No. DVX001/2010

June 2010

## Caution Notice No. DVX001/2010 SLS Cylinder Sealing Surfaces

Fig 1

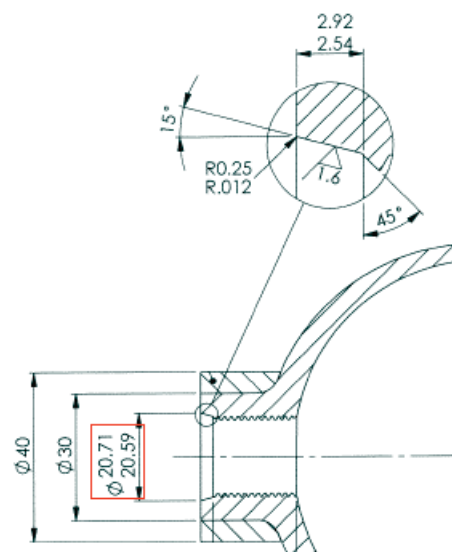
It is advised that a visual inspection must be carried out on the cylinder / manifold interface, to verify that the sealing surface detail is correctly machine to drawing (see Figure 1). Figures 2 and 3 on the following page highlight the difference between cylinders that have correct and incorrect sealing surfaces as they are assembled with the manifold.

The manifold and cylinders should be removed from the backpack for visual inspection. If the cylinder neck butts directly up to the manifold and fully encapsulates the o-ring it is correct. If there is a gap visible between the cylinder neck and manifold it is incorrect.

**Fig 2** Correct cylinder / manifold assembly

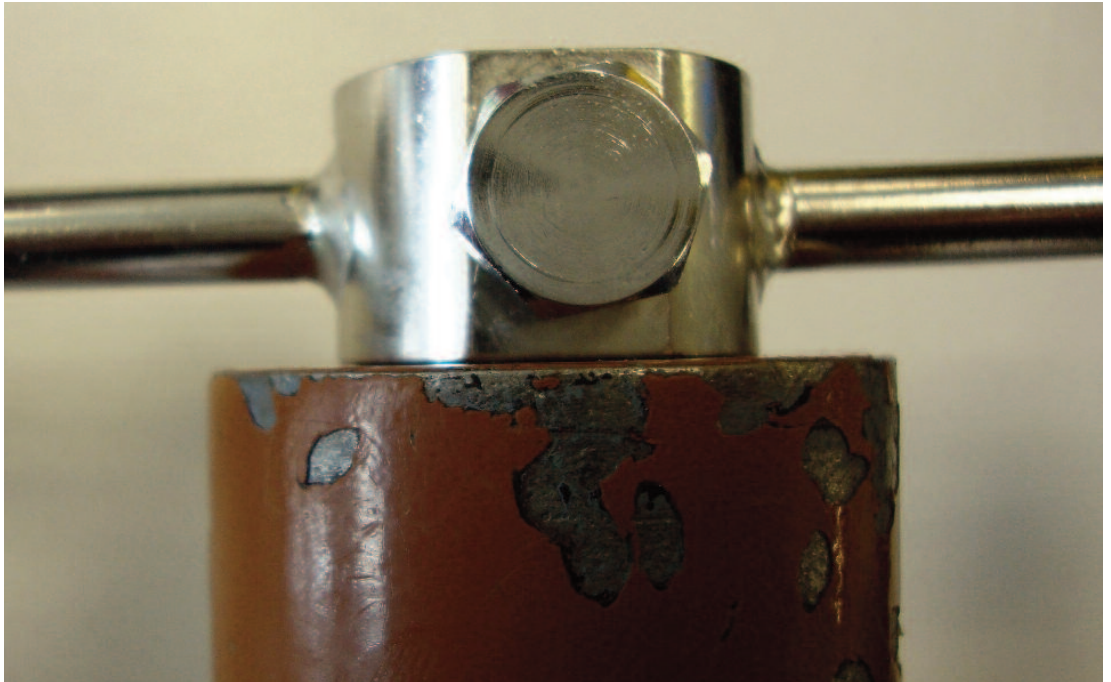
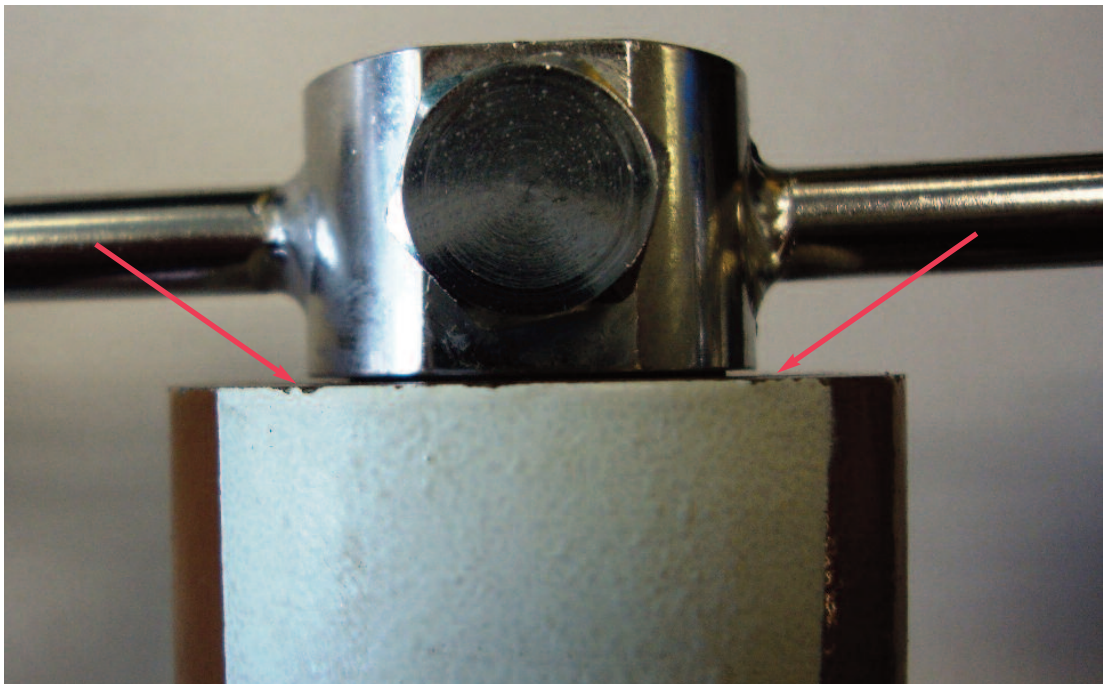
Recent production of SLS MKIV systems highlighted that a particular batch of M275 cylinders included some with undersized sealing surfaces. This can prevent the cylinder from being screwed fully onto the manifold. In such cases the cylinder does not butt directly up to the manifold and the o-ring is not fully encapsulated. It can compromise the integrity of the gas system if the o-ring is damaged by the cylinder thread as it is squeezed into the undersized cavity.

If the cylinder cannot be screwed smoothly onto the manifold until it there is no visible gap the cylinder should be removed and o-ring RN908-7 inspected for damage. Damaged o-rings suggest the cylinders have met and overcome excessive resistance while being screwed onto the manifold.
